<b>T.I. no.:</b> 2018 - 05 <b>Updated:</b> -	<b>Topic:</b> New drip tray
---	-----------------------------

<b>Date:</b> 27.03.2018
<b>Affected machines:</b> SC Soul
<b>From serial number:</b> 1810.../
<b>As of date:</b> -

## NEW DRIP TRAY

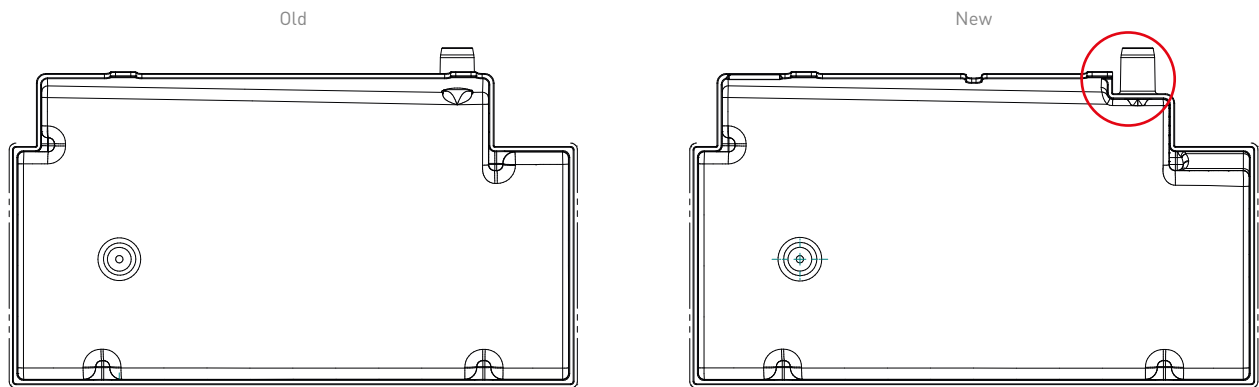
The drip tray (079878) has been redone to facilitate the assembly of the drain hose and prevent incorrect assembly. In addition, the hose can now be secured with the hose clamp (066794).

**i** A drip tray with faulty material has been installed for machines up to and with S.N. 1752Xxx.../. Affected customers which have not yet received a new drip tray can order a new drip tray free of charge by the end of July through their normal sales contact.
